ADDENDUM ONE

Addendum One to the drawings and specifications prepared by Myszak + Palmer for **Pantheon Business Theatre Renovations** for **Pantheon Board of Directors**, Vincennes, Indiana.

FIRST FLOOR DEMOLITION PLAN

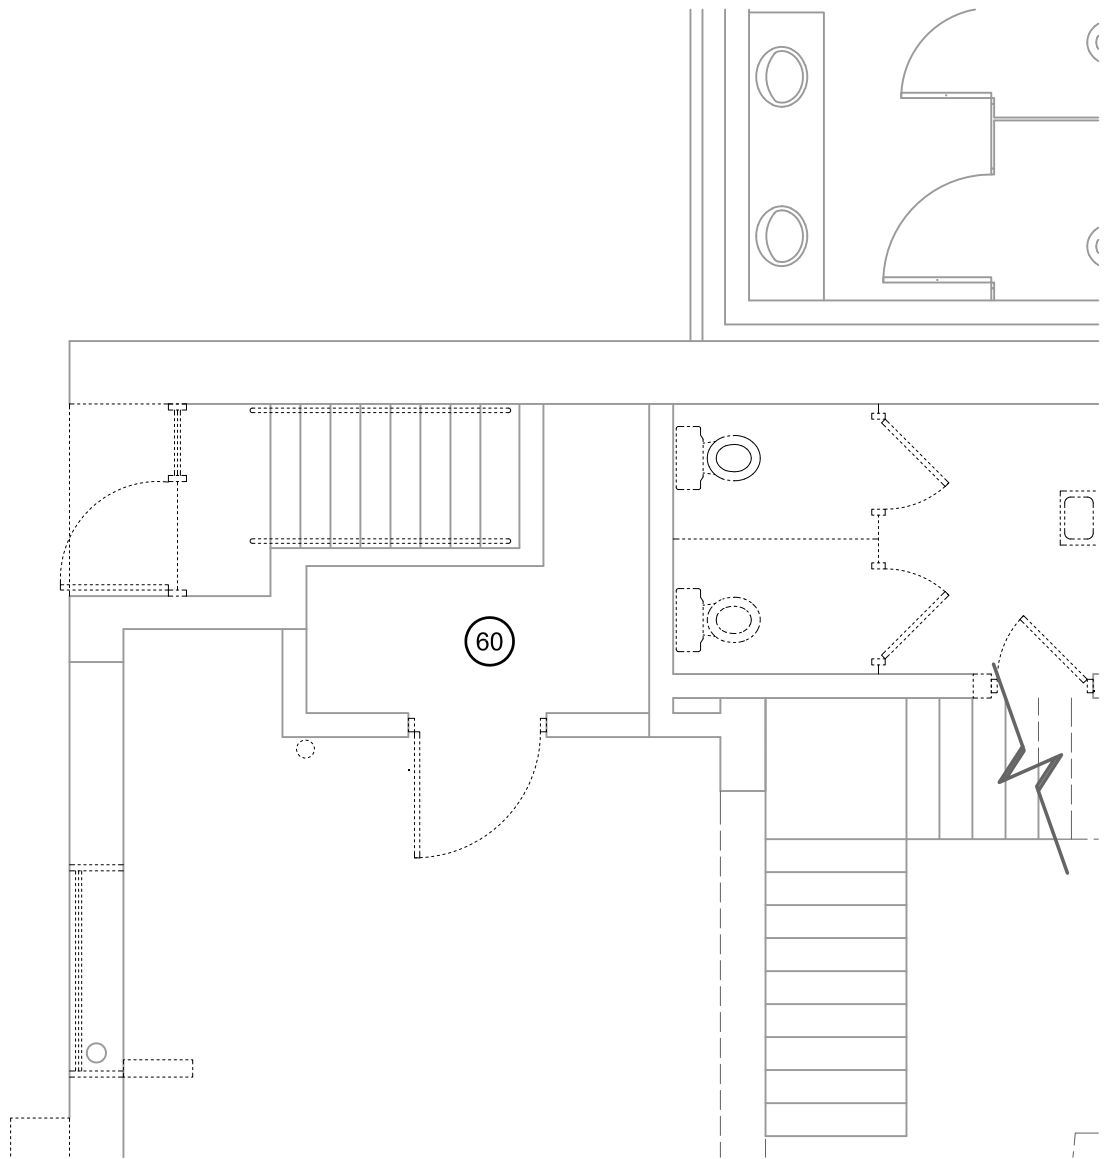
NOTE: REMOVE KEYNOTE 45
AND REPLACE WITH KEYNOTE
60

SECOND FLOOR DEMOLITION PLAN

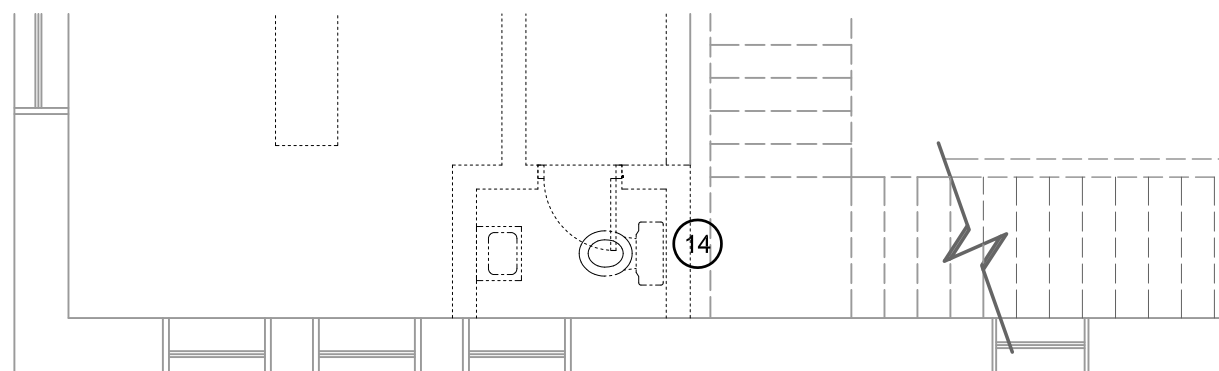
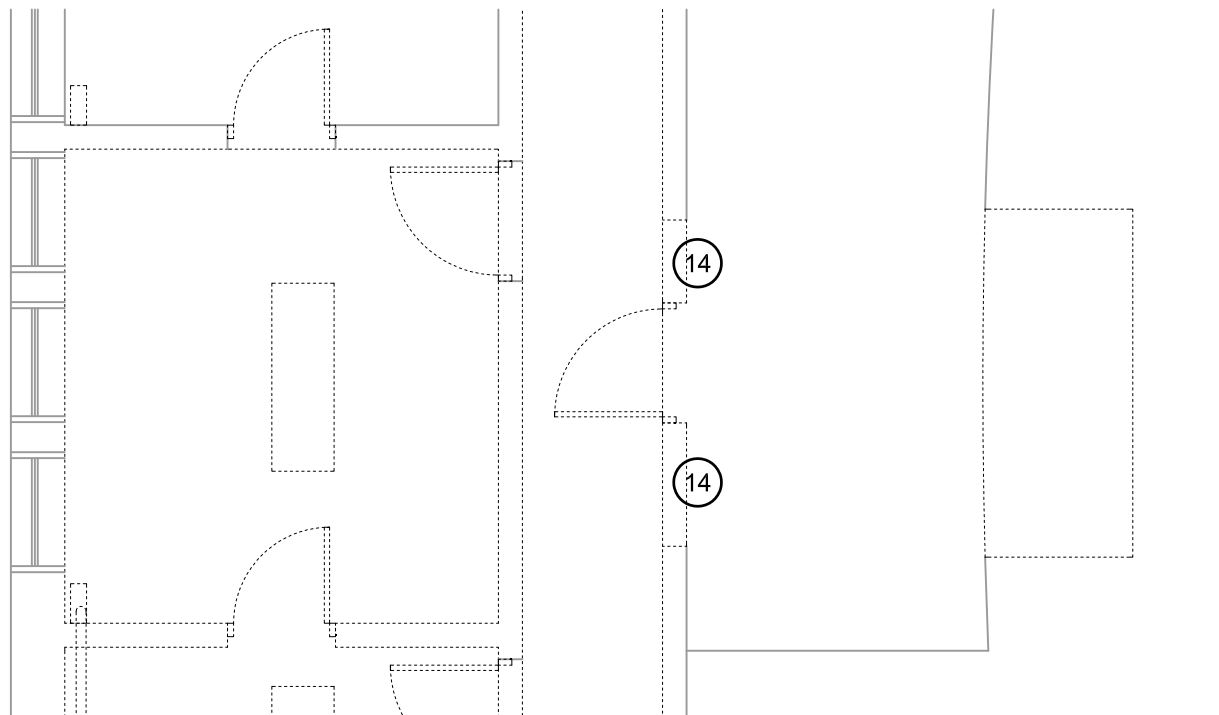
NOTE: REMOVE KEYNOTE 5
AND REPLACE WITH KEYNOTE
14

THIRD FLOOR DEMOLITION PLAN

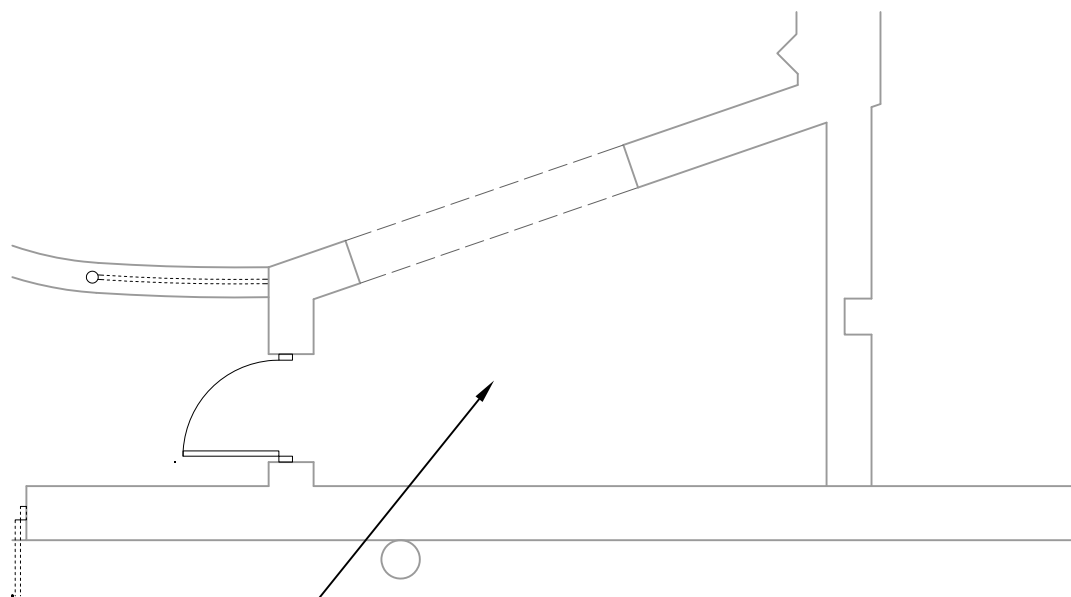
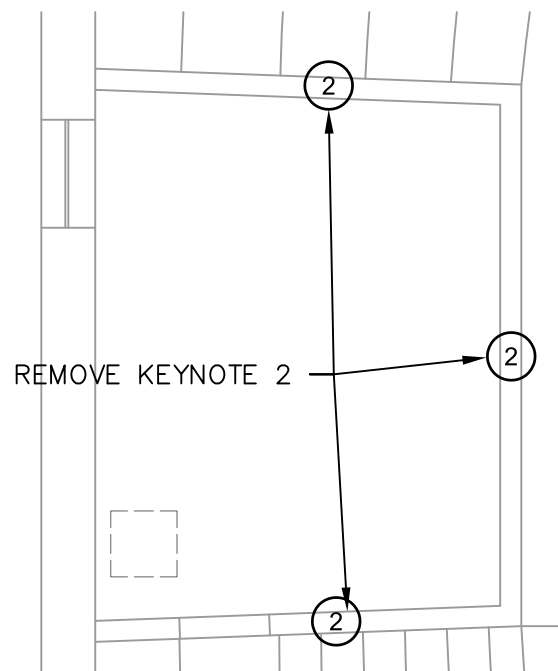
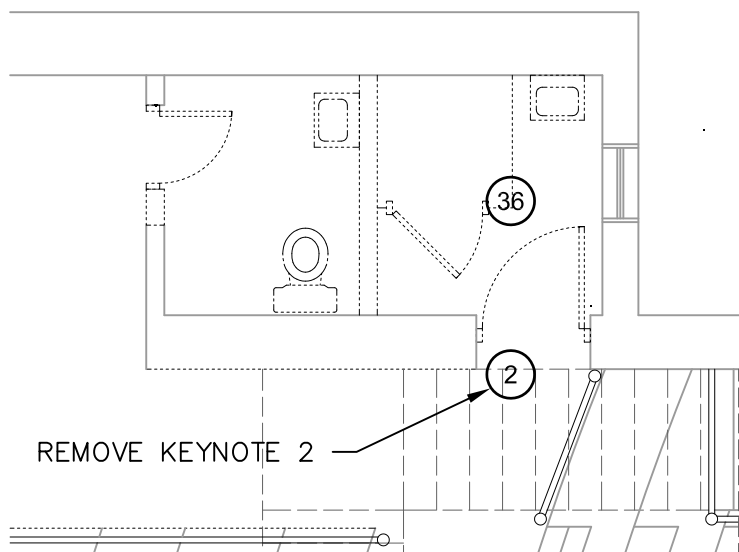
REMOVE ALL DEBRIS FROM
THIS ROOM. SEAT BACKS TO
REMAIN PROPERTY OF OWNER
